Western Sydney Aerotropolis Land Use and Infrastructure Implementation Plan (LUIIP) Submission by the University of Sydney

**Western Sydney Aerotropolis Land Use and Infrastructure Implementation Plan
(LUIIP) Submission by the University of Sydney**

REVIEW OF WESTERN SYDNEY AEROTROPOLIS: DRAFT LAND USE AND INFRASTRUCTURE IMPLEMENTATION PLAN STAGE 1: INITIAL PRECINCTS

**By
BBC Consulting Planners
with inputs from Cardno, Warren Smith and Partners, and at&i**

Figure 8 PMF Extents (After LUIIP, 2018)

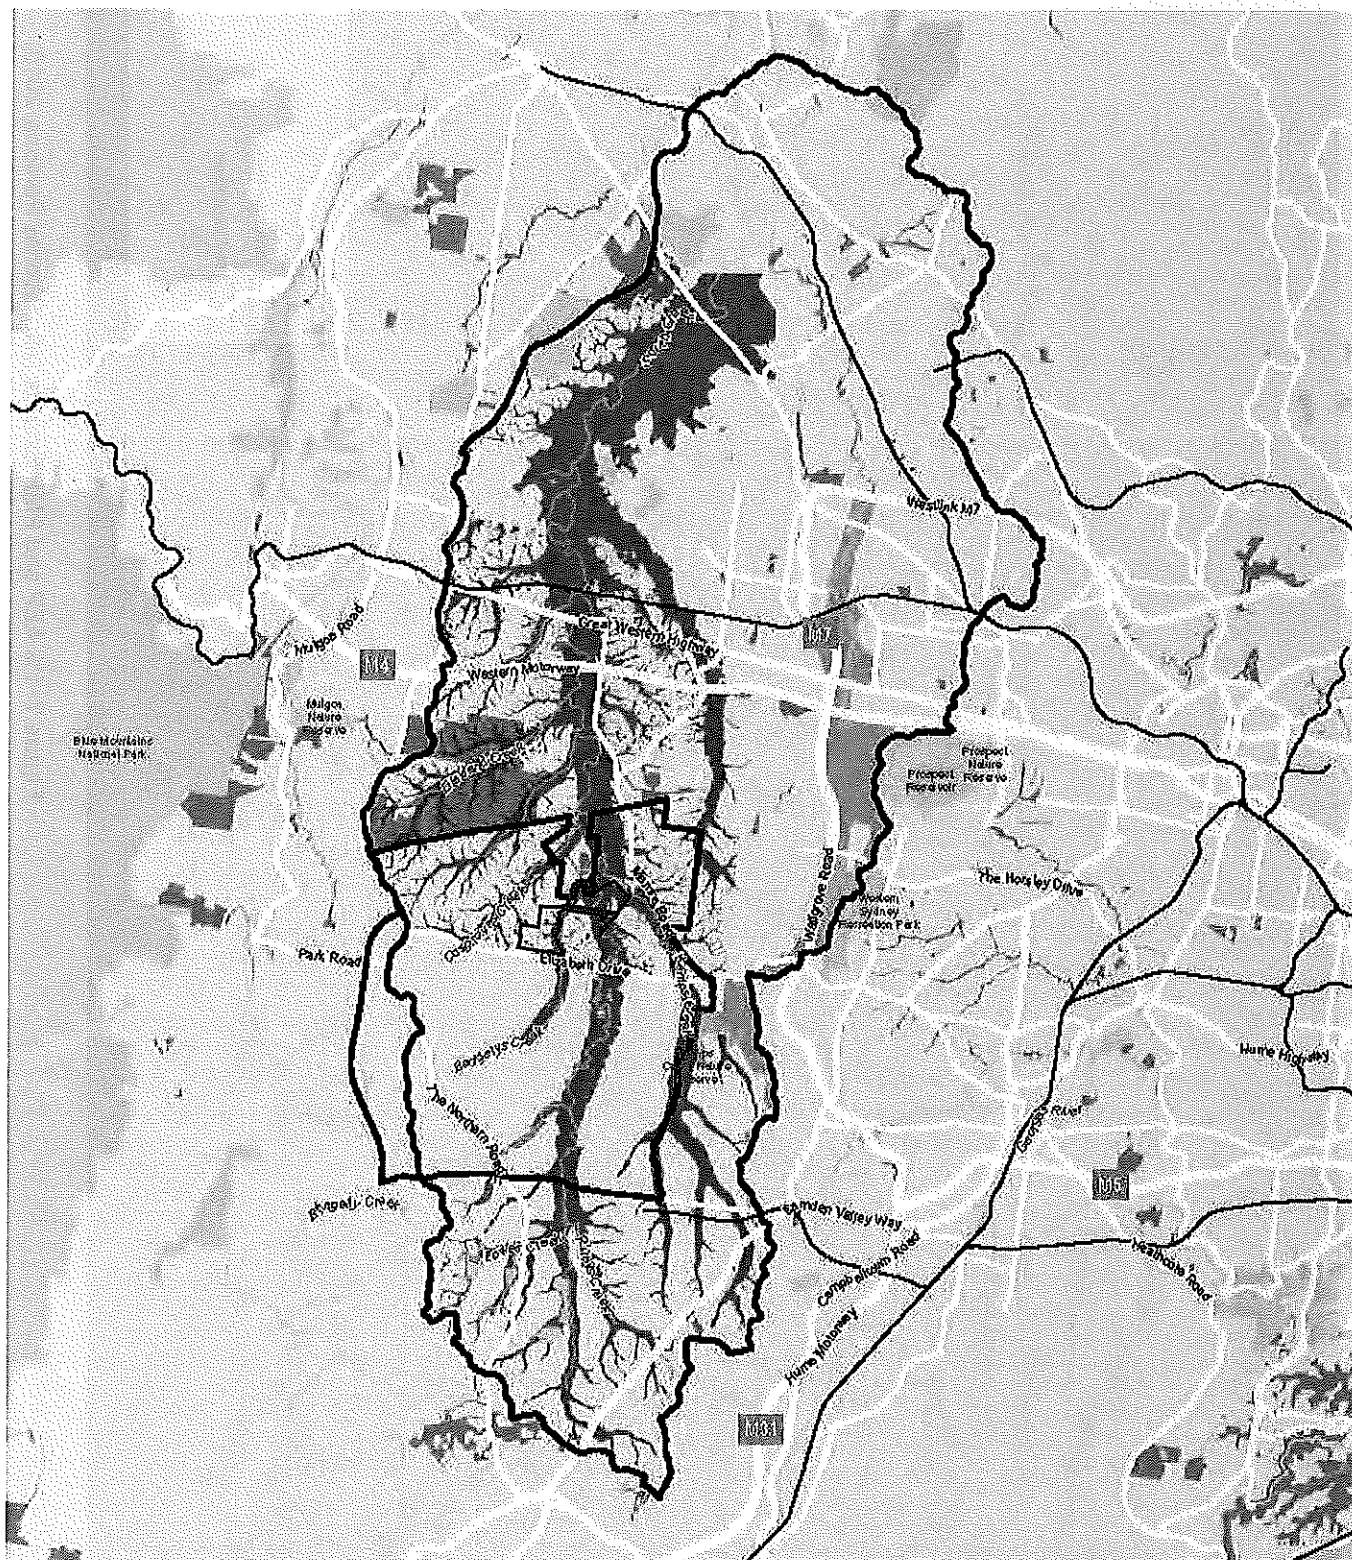
It appears that the South Creek Precinct boundaries are based on the PMF extent mapped by Jacobs, 2017 (refer Figure 8) and that the boundary is either at or beyond the PMF extent. It is also noted that the precinct boundary appears to reflect mainstream flooding and overland flow flooding and that the boundaries are up to 1 km apart along a substantial length of South Creek.

It appears that the South Creek Precinct boundaries are based on the PMF extent mapped by Jacobs, 2017 (refer Figure 8) and that the boundary is either at or beyond the PMF extent. This is inconsistent with the provisions of Penrith Development Control Plan 2014 because it prevents development of 38.9 ha of land within the property in areas between the mainstream 100 yr ARI flood extent and the PMF extent.
